City of Hollywood
Project: **Sheldon Roof Top Addition**
File No.: **17-DP-18**
T.A.C Report Date: **April 24th, 2017**
Responses Date: **May 16th, 2017**

RESPONSES TO T.A.C. COMMENTS (UNDER DELTA # 1)

RESPONSE COMMENTS TO TECHNICAL ADVISORY COMMITTEE REPORT

FILE NUMBER: 17-DP-18

DRWG. TITLE : LANDSCAPE PLAN 4th FLOOR

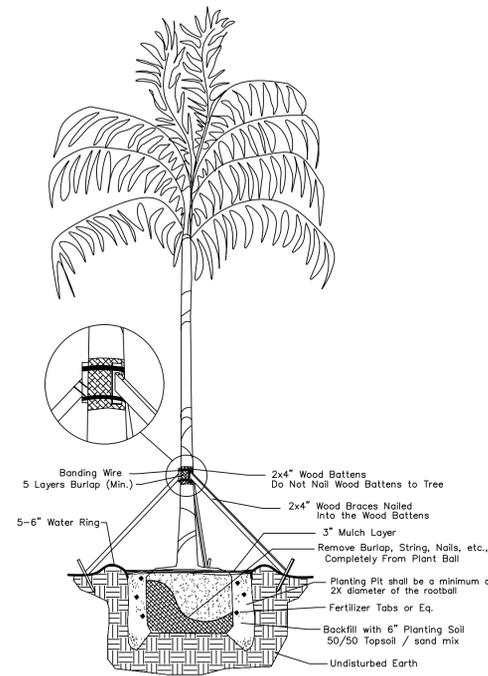
a. Two (2) Coconut Palms in each 24' length planter spaced approximately 15' on center. Consider more unique and attractive cultivars such as Golden Malayan Dwarf or Red Spicata Dwarf, both available at nurseries at the time of this review comment.

b. A continuous single-row (inline) planting of *Clusia guttifera* 'Compacta' (Dwarf Littleleaf Clusia) spaced at 30" on center with a minimum planted dimension of 24" x 24".

c. An approximately 2" layer of medium washed seashell mulch over fabric weed barrier secured in place.

d. Provisions for automatic irrigation via a low-flow, dripline type system. Determine with MEP consultant if the source for this can be a tap from an existing potable service line or interior lateral with backflow preventer/etc. per Code.

RESPONSE: See Sheet LP-1. Golden Malayan Coconut palms are proposed.

RESPONSE: See Sheet LP-1. Dwarf Little Leaf Clusia added along boardwalk.

RESPONSE: See Sheet LP-1. Note added.

RESPONSE: See Sheet LP-1. Note added to be provided at time of permit drawings.

SHEET TITLE
SITE PLAN

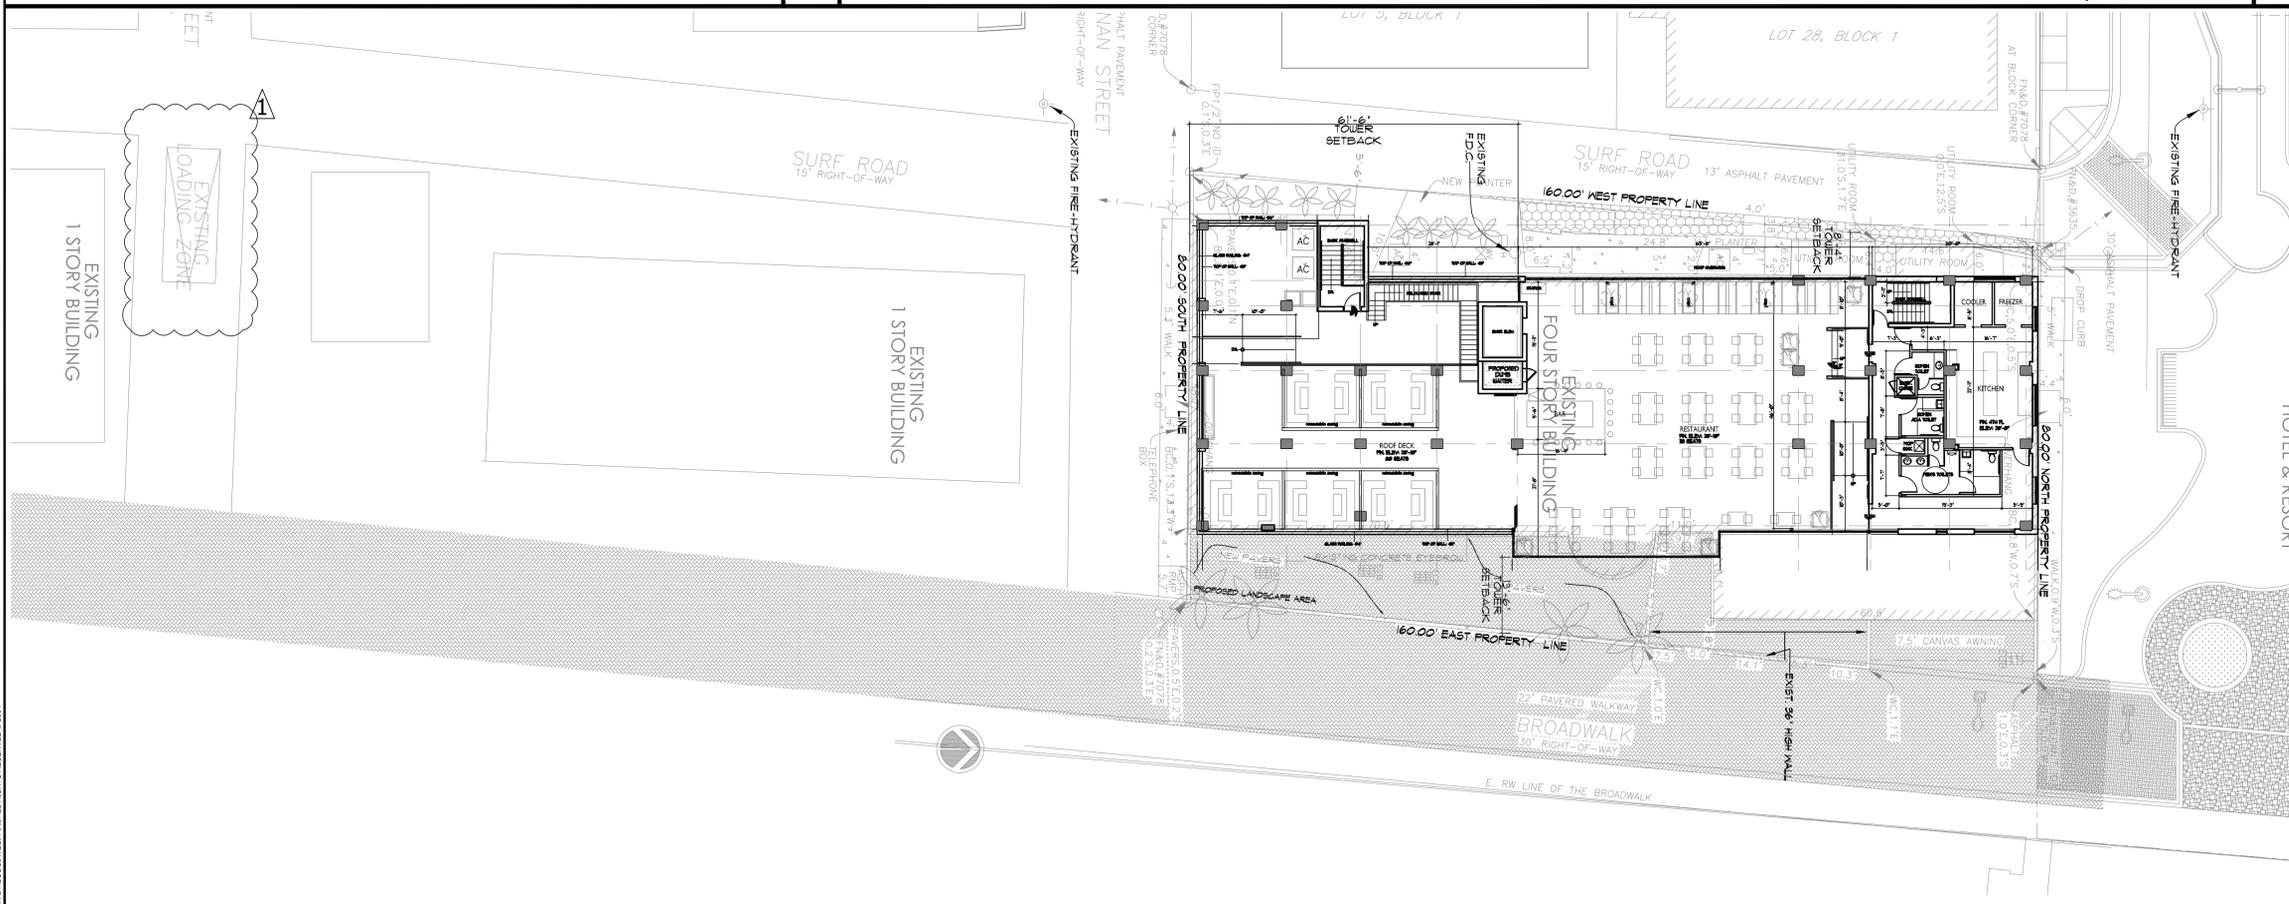
4. Site Plan:
 - a. Illustrate the proposed restaurant addition. **Response: Revised. See SP-1**
 - b. Provide a box for Site Data and include tabular information such as:

- c. Current Land Use & Zoning designations. **Response: Revised. See SP-1**
 - d. Required and provided building setbacks. **Response: Revised. See SP-1**

- v. Provide a note stating the maximum foot-candle level at all property lines (maximum 0.5 f.c. if adjacent to residential). **Response: Revised. See SP-1**

4. Reduce the maximum height of the proposed restaurant addition to the maximum allowed 40-feet from the Median Established Grade. **Response: A height variance from 40'-0" to 48'-0" is being applied for. See variance box on SP-1.**
5. Provide the proposed Green Building practices. **Response: Revised, See SP-1.**
6. Illustrate the method of mail delivery. **Response: Mail is delivered at front desk trough entry at Surf Road**
7. Project is required to install electric vehicle charging station infrastructure, please see Ordinance O-2016-02. **Response: The parking requirement for the Hotel is 0- (grandfathered-in) and the parking requirement for the proposed restaurant is also 0- therefore, Not Applicable.**

1. Proposed improvements shall comply with Chapter 108 of the City's Code of Ordinances, entitled "Lighting Requirements for Marine Turtle Protection," and applicable local, regional or state regulations for lighting standards for nesting sea turtles. **Response : Revised, see SP-1**

1. Make sure that external lights meet the turtle lighting standards. **Response : Noted, note added on SP-1**
2. External lights should also meet Dark Skies standards. **Response : Noted, note added on SP-1**

SHEET TITLE
 NORTH ELEVATION

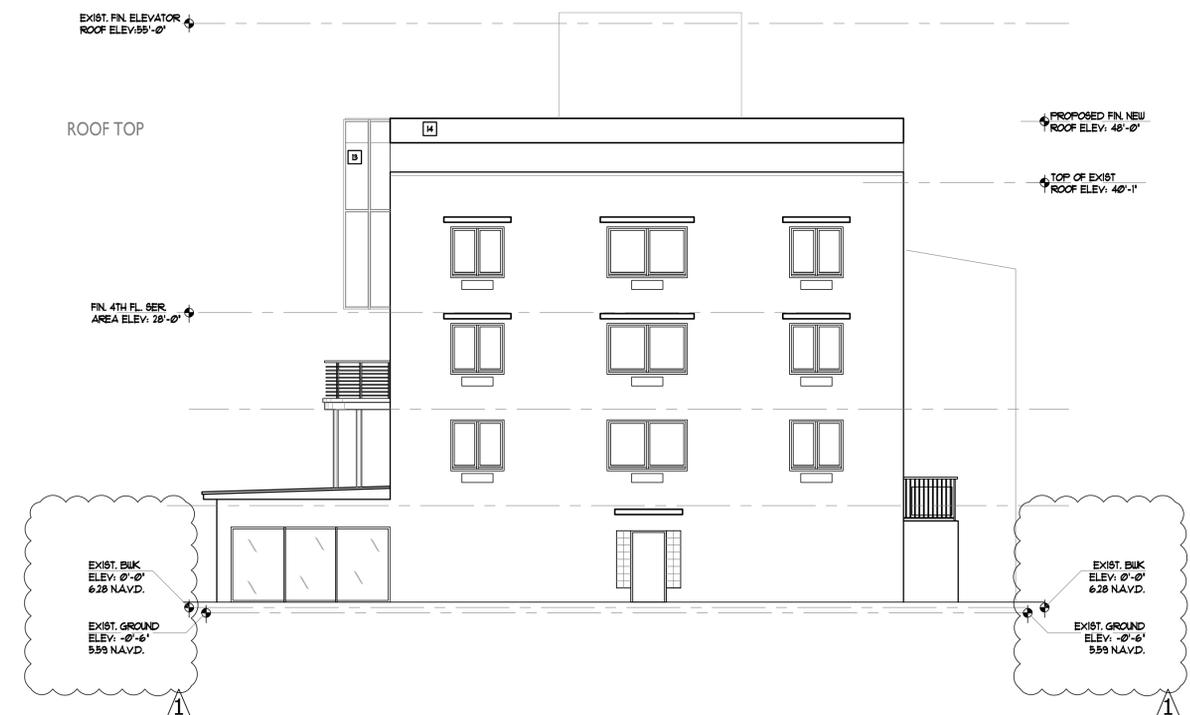
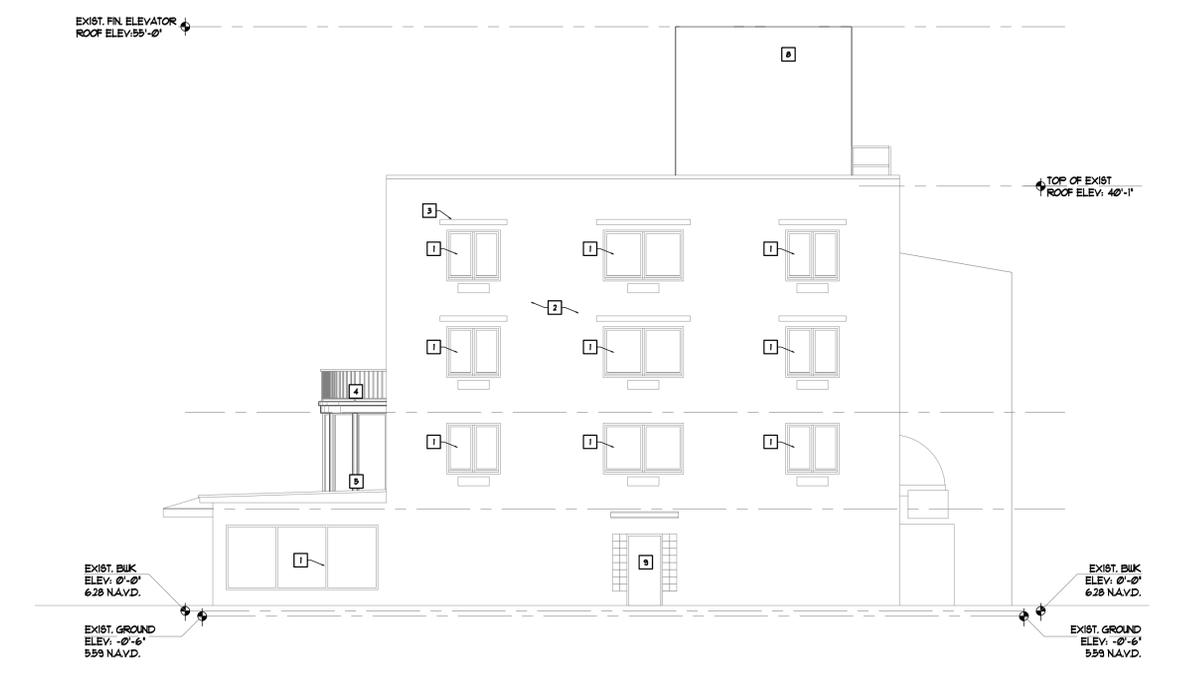
11. Provide elevations from and labeled to the north, east, south and west for existing and proposed, so that the variations in design can be compared. **Response: Revised. See A5, A6, A7 & A8.**

12. For the 0'-0" marker, provide the vertical datum value in NAVD 88 and provide a note stating the 0'-0" is based on the Median Established Grade **Response: Revised. See A5, A6, A7 & A8.**

13. List all existing and proposed building materials and treatments. **Response: Attached, See elevation sheets : A5, A6, A7 & A8.**
14. Provide a Street Profile drawing. **Response: Revised. See SP-3.**

18. Provide elevation marker for the highest portion of the hotel. **Response: Revised. See elevation sheets : A5, A6, A7 & A8.**
19. Confirm with local, county, state and national historic preservation agencies that this property is not listed on any registries. **Response: Confirmed, it is not listed on any state or National registry.**

10. Exterior Elevations: No materials are called out on the elevations. I cannot tell what work is being done on the existing elevations of the hotel. Are the windows being replaced? **Response : All windows on the hotel are existing to remain. Materials called now on sheets A5, A6, A7, A8 & A9 for further information.**

1. The CRA understands signage in rendering is not indicative of the final design; however, please ensure all future signage will be sensitive to the historic nature of the building and the existing building signage. **Response: Revised rendering and elevations showing signage not to exceed 15sqft.**
